**Re: Construction Storm Water Inspection at Ohio Army National Guard Regional Training Institute/ Franklin County  
Permit Number 4GC03176\*AG**

This letter is written in follow-up to a construction storm water inspection conducted by Stephen Riley and Mike Shields of Ohio EPA at Ohio Army National Guard Regional Training Institute located at DSCC – 3900 East Broad Street, Columbus, Ohio on August 11, 2010. The purpose of the inspection was to evaluate compliance with the General Storm Water Permit Associated with Construction Activities. The following was noted:

Figure 1: Lack of controls around outlet

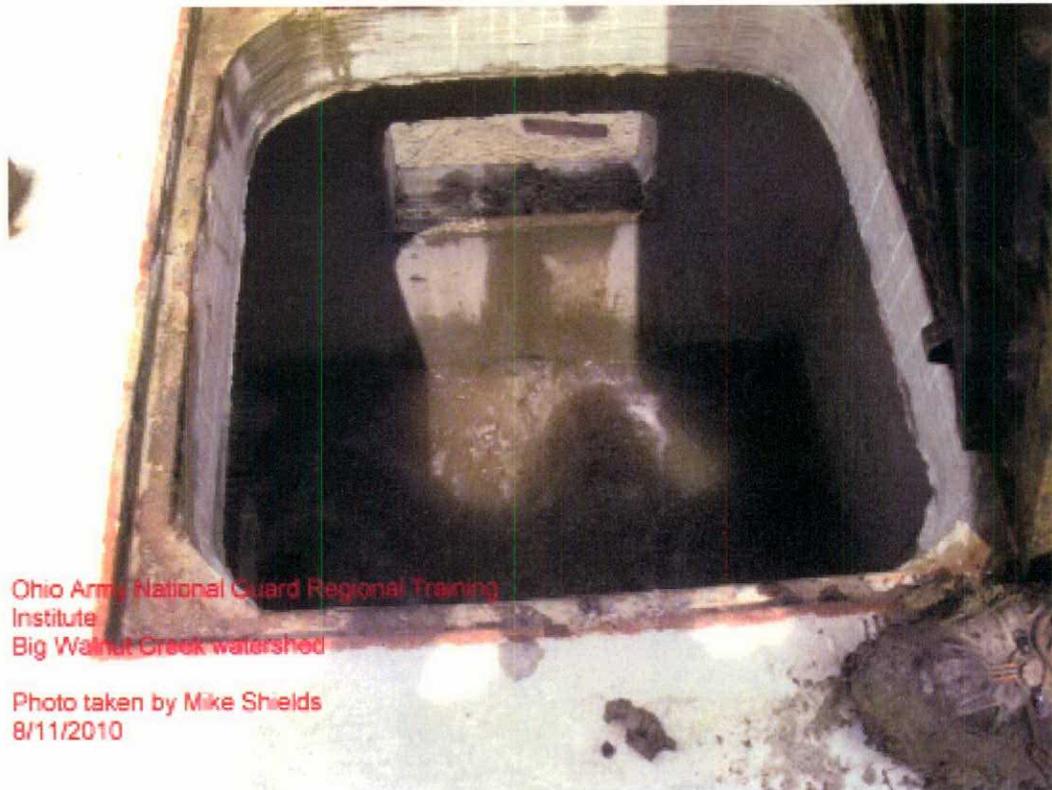
- The detention basin noted onsite must be modified to address sediment control via the installation of a temporary riser. This will allow for additional settling time for the suspended solids to settle prior to a final discharge from the site (Figure 1 and 2).
- The silt fence running adjacent to Eighth Boulevard requires maintenance as it appears it is allowing sediment to flow onto the adjacent road (Figure 3).
